# Access Compliance Report

## Public Rights-of-Way

### (Curb Ramps)

Intersection ID: 52450	Main Street: TRANQUIL_OAK_PL	Cross Street: MOSS_LN	Location: SE
ADA ID: E1F80ACD8CBA	Ramp Type: BlendTrans1	Initial Pass/Fail: Fail	Overall Compliance: No
Severity Score: 1.25			
Codes/Mitigation Info/Possible Solution		Field Measurements/Component Compliance

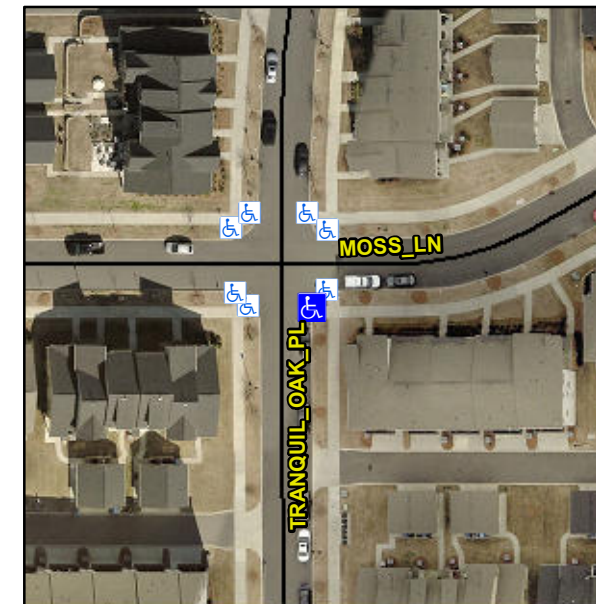
**Not Found, R304.5.3**

Compliance	Description	Data	Compliance	Description	Data
N/A	Ramp Length (in)	82.0	Yes	BlendTrans Slope (%)	1.9
Yes	Ramp Width (in)	67.0	No	BlendTrans XSlope (%)	3.0
N/A	Flare Type LT	N/A	N/A	Flare Type RT	N/A
N/A	Flare Slope LT (%)	N/A	N/A	Flare Slope RT (%)	N/A
N/A	Flare Traversable LT?	N/A	N/A	Flare Traversable RT?	N/A
N/A	Landing Length (in)	N/A	N/A	DWS Provided?	N/A
N/A	Landing Width (in)	N/A	N/A	DWS Contrast?	N/A
N/A	Landing Slope (%)	N/A	N/A	DWS Length (in)	N/A
N/A	Landing X Slope (%)	N/A	N/A	DWS Full Width?	N/A
N/A	Landing Curb? (Y/N)	N/A	N/A	DWS Offset (in)	N/A
N/A	Shared Landing?	N/A			
N/A	Gutter Ponding?	N/A	N/A	Gutter Slope (%)	N/A
N/A	Gutter Lip Ht (in)	2.0	N/A	Gutter X Slope (%)	N/A
N/A	Painted X Walk1?	No	N/A	Painted X Walk2?	N/A
	X Walk 1 Direction	To W		X Walk 2 Direction	N/A
	X Walk 1 Width (in)	N/A		X Walk 2 Width (in)	N/A
	X Walk 1 Slope (%)	3.5		X Walk 2 Slope (%)	N/A
	X Walk 1 X Slope (%)	2.1		X Walk 2 X Slope (%)	N/A

N/A	Ramp inside XWalk1?	N/A	N/A	Ramp inside XWalk2?	N/A
	Road Slope (%)	2.1		Clear Space?	N/A
	Road X Slope (%)	3.5	N/A	Clear Space to XWalk (in)	N/A
N/A	Any Obstructions?	N/A	N/A	Storm Grate/Utility Hazard?	N/A
	Obstruction Type			Storm Grate/Utility Type	
		N/A			N/A
			Yes	Surface Condition? (G/P)	Good
			No	Curb Slope (%)	6.6

**Remove & Replace Curb Ramp With Two New Directional Ramps or Equivalent.**
